# Assessment Officer Report

31 Waterway Boulevard,  
Weir Views

Officer Assessment Report  
Development Approvals & Design

Key Information		Details		
<b>Application No:</b>	PA2403059			
<b>Received:</b>	6 August 2024			
<b>Statutory Days:</b>	19 days			
<b>Applicant:</b>	Melbourne Archdiocese Catholic Schools (MACS) c/- Ethos Urban			
<b>Planning Scheme:</b>	Melton			
<b>Land Address:</b>	31 Waterway Boulevard, Weir Views			
<b>Proposal:</b>	Construction of a building and carrying out of works for an ancillary education centre (early learning centre) (land use as of right) and display of business identification signage.			
<b>Development Value:</b>	\$ 8.06 million			
<b>Why is the Minister responsible?</b>	<p>In accordance with Clause 72.01 of the Melton Planning Scheme, the Minister for Planning is the responsible Authority for this application because:</p> <ul style="list-style-type: none"> <li>• Proposal seeks consent for an education centre that is ancillary to, carried out in conjunction with and on the same land as a primary school.</li> <li>• Proposed development cost exceeds \$3 million.</li> </ul>

Figure 1 Toolern Urban Structure Plan, subject site circled

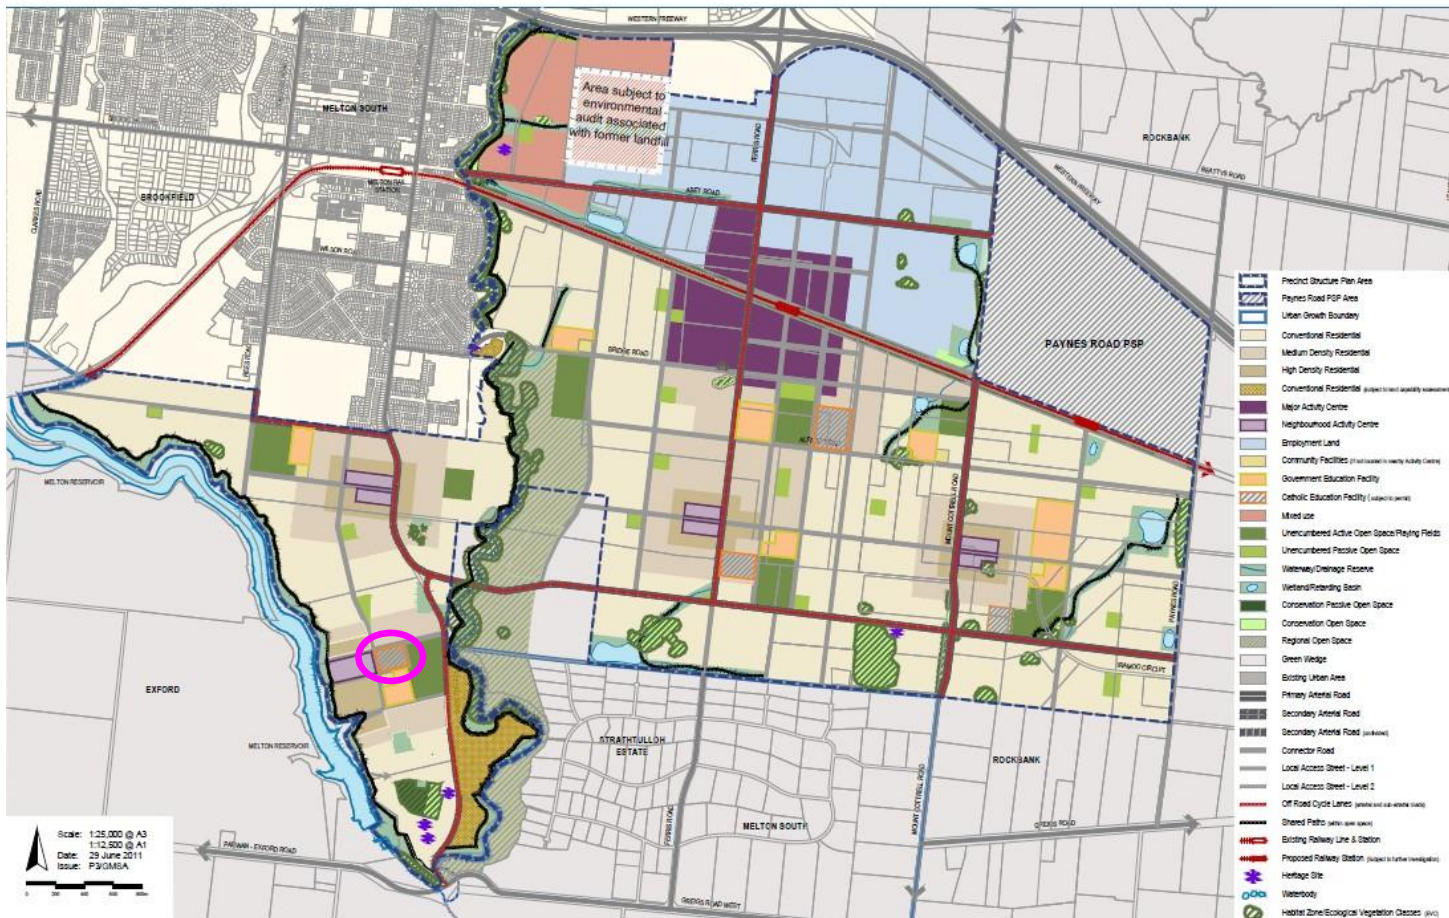
Council Comment	Applicant Response	DTP Response
<p>A review of the site in relation to the wider Toolern Precinct Structure Plan (PSP) context shows that the site is located opposite a small Neighbourhood Activity Centre (NAC) and adjacent to a future community centre (refer to Figure 1).</p>  <p>Figure 1   Toolern PSP Context</p> <p>This context should be taken into consideration. The endorsed site plan under Planning Permit No.PA2019/6745/1 shows more activation on the southwestern corner of the site (refer to Figure 2)</p>  <p>Figure 2   Endorsed vs This Application</p>	<p>We note that an amended site plan and staging plan under Planning Permit No.PA2019/6745/1 has been recently endorsed by Council on 4 October 2024. The endorsed plans show the location and building footprint of the Children's Hub as consistent with this application. A copy of the endorsed plans is attached at Appendix F.</p> <p>The endorsed plans do not identify specific built form outcomes. Whilst it is noted that the previously endorsed plans showed the Children's Hub situated closer to the Brewers Way frontage, this cannot be accommodated without a substantial loss of floor area.</p> <p>The proposed layout will locate car parking in the front setback. Generous landscaping will be delivered within the car park, including 14 canopy trees to provide an attractive interface with Brewers Way. The proposal is consistent with the masterplan recently endorsed by Council. Meaningful landscaping will be delivered with the Children's Hub to compliment the Brewers Way and Oldbridge Road streetscapes and provide visual amenity to the surrounding area as expected within the Toolern PSP.</p>	<p>Applicant has provided a copy of most recent plans endorsed under planning permit PA2019/6745/3, which identifies the development of children's hub in the location consistent with this proposal.</p> <p>While the layout has not been amended to provide improved interface with the adjoining properties which are earmarked for a future activity centre and community centre, the extent of landscaping has been increased to improve general visual amenity.</p> <p>Childcare centres are generally required to be secured from the public realm with fencing/ gates and as such do not typically provide a high level of street activation, compared with other community infrastructure. The proposed layout is considered acceptable.</p>

Figure 5 Children's hub site plan

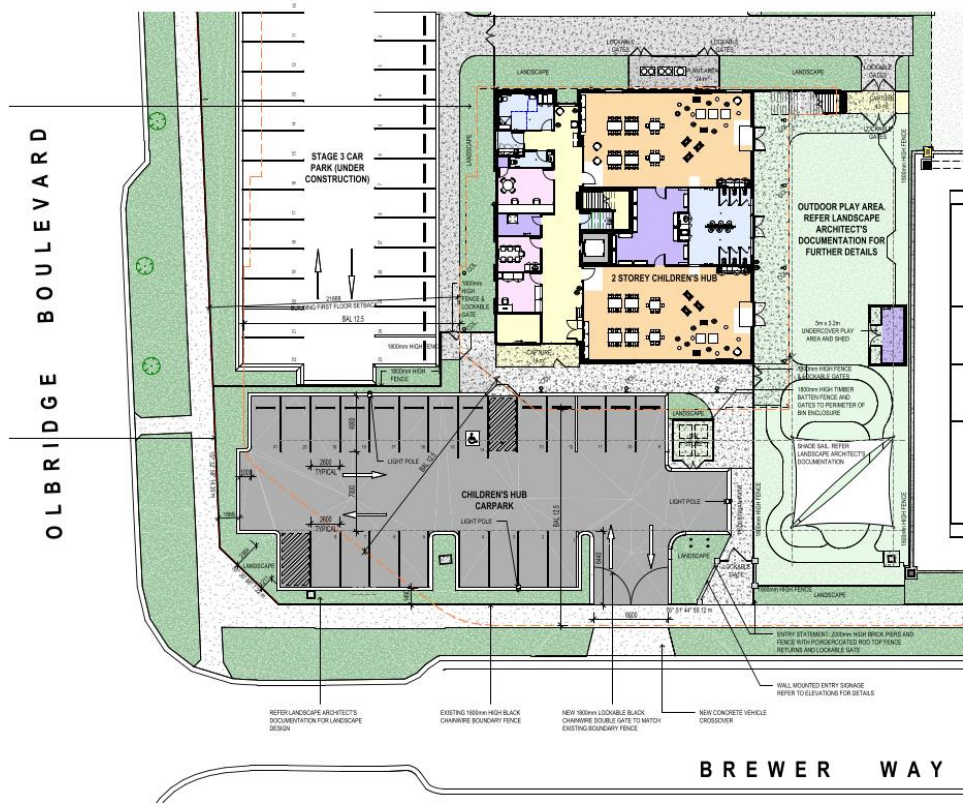
Council Comment	Applicant Response	DTP Response
 <p>Figure 3  </p> <p>Avoid extending the carpark to sit forward of built form and / or wrap around the corner.</p> <p>(1) Built form to front onto Brewer Way.</p> <p>(2) Main Entrance to be clearly visible and accessible from the street.</p> <p>(3) North facing play yards.</p> <p>(4) A widened entrance plaza to activate and visually connect the NAC and Community Centre with the school site (refer to the examples below).</p>	<p>The operating hours of the school and Children’s Hub will overlap. Combining the school and Children’s Hub parking using tandem parking spaces creates the risk of staff being unable to exit the site as another car has parked in the rear tandem space.</p> <p>The Children’s Hub will be fenced and gated to create a secure site which is required for the ELC component of the building. The suggested entrance plaza and public pathways would present a significant security issue to the kindergarten and school children and would be difficult to manage by the school.</p> <p>The proposed layout has been amended to ensure the main entrance is clearly visible and integrated with the Brewer’s Way streetscape. The pedestrian entrance to the Children’s Hub on Brewers Way has been widened and includes a feature stone wall with signage to create an improved sense of entry to the site from the street. This will ensure the pedestrian entry is clearly the entrance to the Child’s Hub.</p> <p>Amendments have also been made to improve the extent of landscaping interfacing with both street frontages.</p> <p>An additional 6 canopy trees are included along the southern boundary of the outdoor play area that interfaces with Brewers Way. The car park has been amended to include larger garden beds, with a total of 14 trees provided within the car park. This landscape response will make vegetation a prominent feature of the proposal to compliment the public realm on Oldbridge Road and Brewers Way.</p>	<p>the street.</p>

<p>The proposed car park does not comply with Melton’s Off-street Carparking Guidelines which requires as a minimum 35% tree canopy coverage within the car park and 15% of the car park footprint landscaped. Every 6th car space must be set aside as a landscape outstand (2.6m wide) capable of accommodating a high canopy tree. This will assist in breaking up the amount of hardstand area within the car park and ensure adequate levels of shade is provided within the car park.</p>	<p>The Melton Off-Street Car Parking Guidelines are a non-statutory document. The Landscape Plan has been amended to include additional tree planting and deliver a total of 14 trees to the Children’s Hub car park.</p> <p>All trees within the car park will have a height and canopy width of between 4m-8m to provide a meaningful landscape response at the site.</p> <p>Further planting is included in garden beds that border the car park to make vegetation a prominent feature of the Children’s Hub from the public realm.</p> <p>The garden bed immediately west of the new crossover has been widened to include 2 new canopy trees. An additional garden bed is included in the southern parking aisle to break up the hardstand area of the car park, particularly when viewing the car park from Brewers Way.</p> <p>This is the maximum amount of landscaping</p>	<p>The site plans and landscape plan have been amended to increase the extent of landscaping. The updated design provides landscapes along all street frontages and achieves 16.03% landscaped area throughout the carparking area, complying with this guideline.</p>

Council Comment	Applicant Response	DTP Response
	<p>the project has been able to accommodate around the carpark without losing parking spaces and therefore reducing the number of child places accommodated by the ELC component of the Child's Hub.</p> <p>The additional landscaping proposed with the Children's Hub car park will achieve a high-quality landscaping response and is consistent with the overarching objectives of the Melton City Council Off-Street Car Parking Guidelines.</p>	
<p>Provision of a high fence should be considered between the play area and basketball / tennis courts to avoid harm to children playing outdoors.</p>	<p>The MACSEYE team consider the 1.8m fencing east of the outdoor play area appropriate to maintain the safe use of the play space adjacent to the basketball and netball courts.</p>	<p>The site plan shows a 1.8-metre-high fence between the existing basketball/netball courts and the proposed ground floor outdoor play area. This is considered practical and sufficient.</p>
